RE: 988 Halekauwila St., Ward Village Land Block 5, Project 1 "Ke Kilohana" (Block O)
Notice of Warranty Claims for Construction Defects

**Warranty Claim
February 28, 2020**

Site Observation Report

To	Howard Hughes Corp.	SOR No	Warranty Review
Attention	Larry Schenk	Date	Feb. 28, 2020
From	Kevin Luoma, Grant Higa Kawe Humel	Email	Kevin.luoma@wsp.com, grant.higa@wsp.com, John.humel@wsp.com
Project	Ke Kilohana HOA Warranty Review	Project No	B2013460
Copies		No. of pages	9

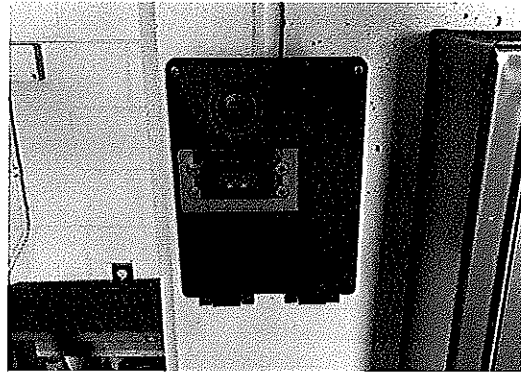
8. Unsure if CO monitors are operational within loading dock.

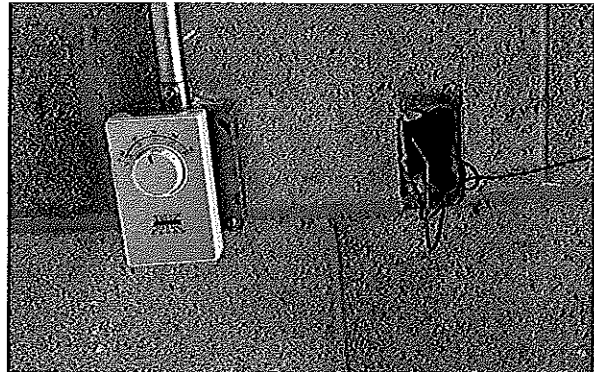
9. T-stat serving EF-12 in Fire Pump room and EF-11 in Level 4 display area does not seem to work properly where it turns on fan we space temperature exceeds setpoint on dial. Fan appear to turn on anytime the setpoint is set above 75F. There is also an open j-box by EF-11 thermostat.

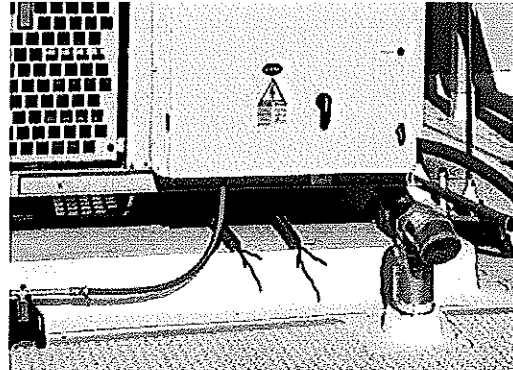
12. Abandoned material under OAU-2.

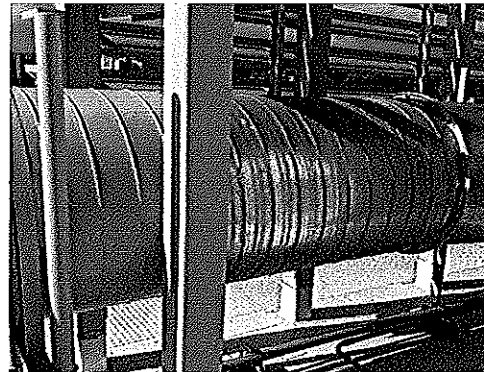
13. Portions of ductwork on roof not painted.

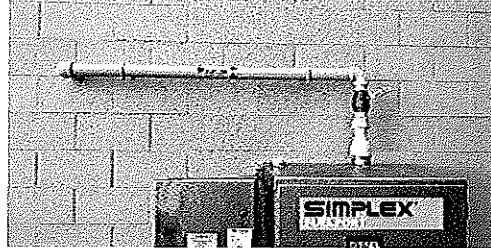
1. Generator fuel filling stating valve not locked in closed position.

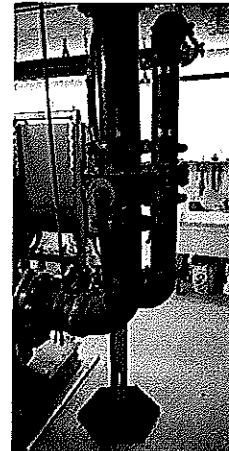
3. No exceptions taken to butterfly valves (BFV) installed on domestic water booster pump outlet. 2006 UPC section 606.0 states valves up to 2" shall be copper, copper alloy, or other approved material (bronze/brass), valves greater than 2" brass or cast iron, and gate / ball valves shall be fullway type. It does not say gate / ball valves only, or that BFV's shall not be used, only that when they are, they shall be fullway (full port).

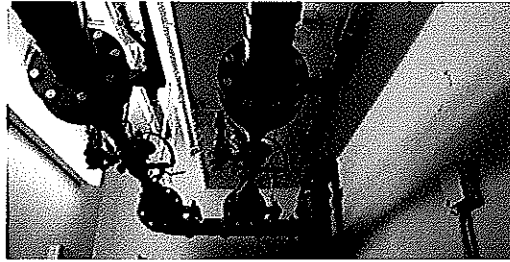
5. Level 8 pressure reducing valve (PRV) station does not appear to be calibrated per P108. Please provide manufacturer's (Cal-Val) calibration and start-up report for all PRV stations (level 8, 15, 22, 29, 36)

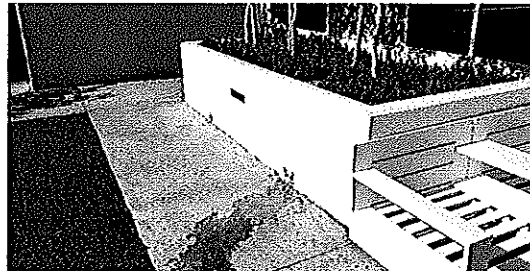
6. Planter drains on Level 8 recreational deck shall connect to storm drain system at Level 7 ceiling per P107. Planter drains shall not discharge to level 8 deck causing nuisance.

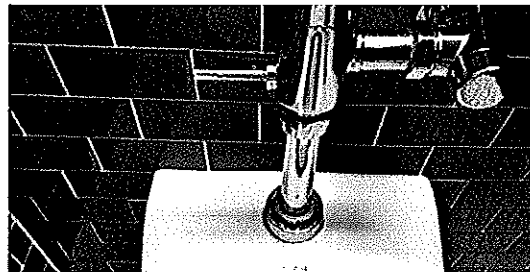
8. Level 8 women's restroom flush valve leaking.

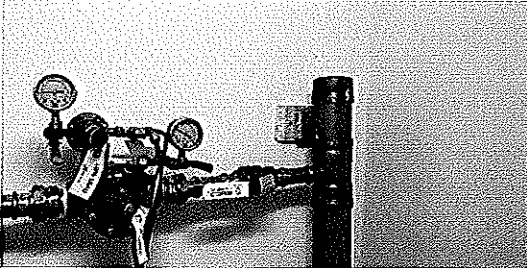
9. Provide proper pipe restraints per 2006 UPC.

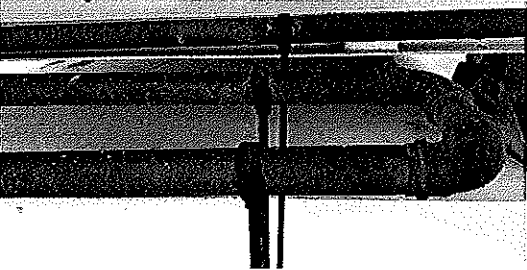
11. Steel clamps on copper piping is not allowed per 2006 UPC. Electrolysis between dissimilar metals occurring on HVAC equipment condensate piping.

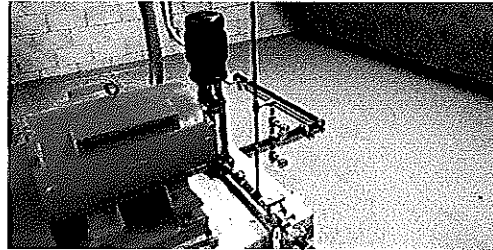
1. Jockey Pump tamper switch does not appear connected.

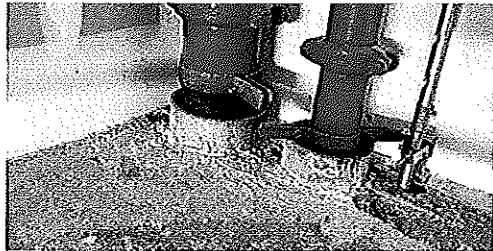
2. Automatic fire sprinkler riser and automatic standpipe riser clamps shall have neoprene pad per FS500/4.

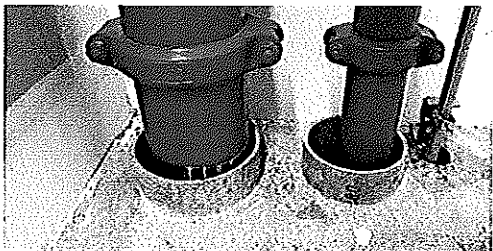
4. Provide riser clamp per FS500/4.

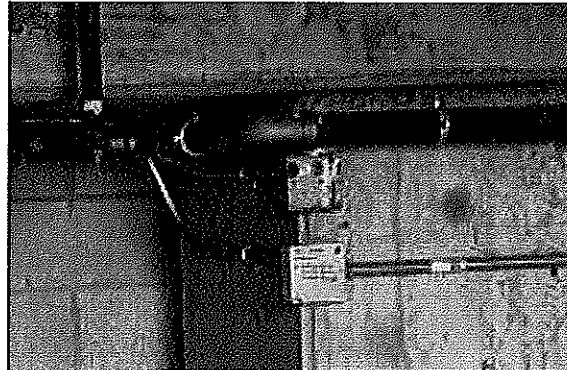
7. It was noted that junction boxes were missing covers in the Residential Trash Room, generator air discharge area, and Elevator Machine Room. Confirm and provide covers as required.
